CKP Railways

Y/ref: DC7/2008/3025
Dated: 28 April 2008

Comments on Planning Application No. 7/ 2008/3025 **Extension to Agricultural Shed, Cocklakes, Penrith, CA11 0SG**

Figure 4: Model structure gauge requiring minimum associated control measures (applicable only to straight and level track)

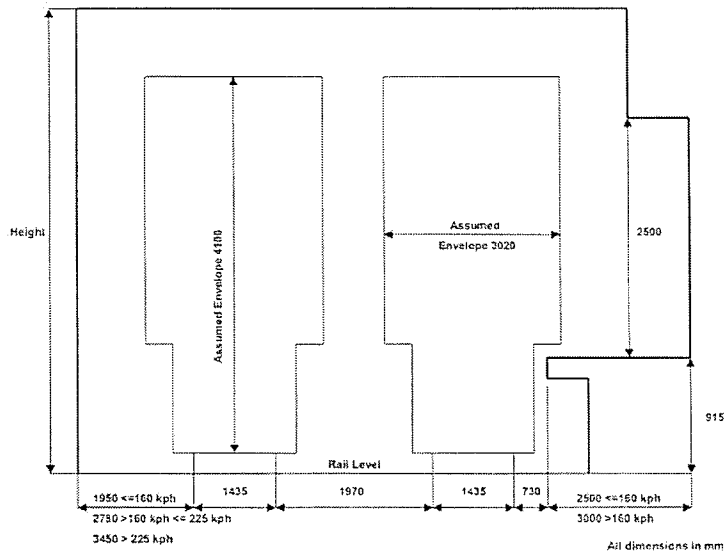
The minimum width for double track, according to the current version of this Guidance Note, is 8740 mm (actually 4370mm either side of the centre line of the existing trackbed) (calculated as 1950+1435+1970+1435+1950 mm from the attached diagram).

This in itself imposes a future maximum passing speed for trains of 160kph (100mph), which should be adequate for our purposes. Please note that the figures quoted amount to an absolute MINIMUM, not an approximation.

I would therefore ask that the "minimum required width" of the trackbed to be retained is interpreted as that width required by modern standards for trains moving at up to 100mph to pass on double track. The Standard extract attached is the basis of future requirements which we will be obliged to work to. The figure we have calculated is 4370mm either side of the centre line of the existing trackbed.
